Product Change Notification

Product Change Notification: P-16-013650

DEUTSCH DT Series Cavity Laser Marking

New vs Current Laser Marking

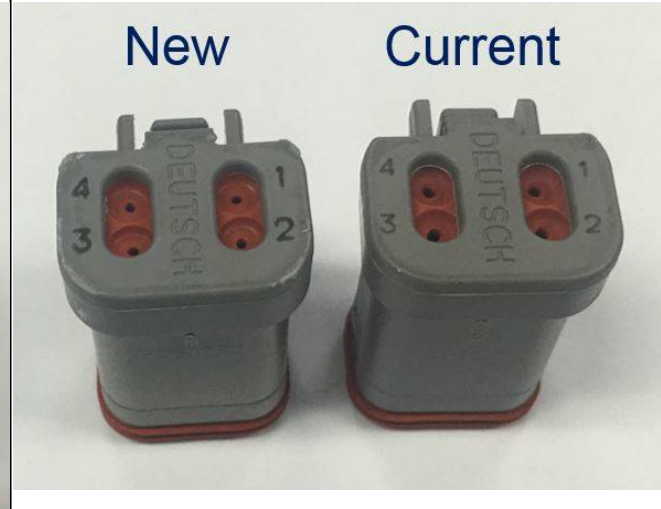
Process Change. Contact cavities identification marking will use new technology type laser.

Product improvement. Dear customer, we are contacting you to notify you of a process change to the contact cavity identification marking on the end cap of the DT Series connectors, plug and receptacles. We are upgrading the marking lasers to use newer laser technology. The only change you will notice is the way the contact cavity marking looks (see photos on this PCN). This change only affects part form and does not affect fit or function. Shipment of both versions may be mixed. IMPORTANT: This is a continual improvement so the current and previous revisions of these parts can be used interchangeably in the field. These changes are being phased in gradually and previous revision can remain stocked until use. The product drawings are not affected.
